Access Compliance Report

Public Rights-of-Way

(Curb Ramps)

Intersection ID: 48880	Main Street: TANGLEWOOD_LN	Cross Street: BRANDON_MANOR_LN	Location: SW
ADA ID: F7AE9371D4B7	Ramp Type: PerpDiag	Initial Pass/Fail: Fail	Overall Compliance: No
Severity Score: 10			
Codes/Mitigation Info/Possible Solution		Field Measurements/Component Compliance

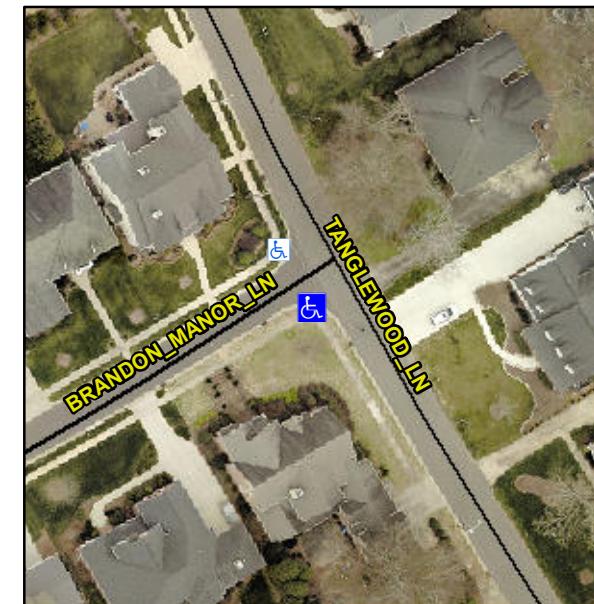
Not Found, R304.5.1

Remove & Replace Curb Ramp With Two New Directional Ramps or Equivalent.
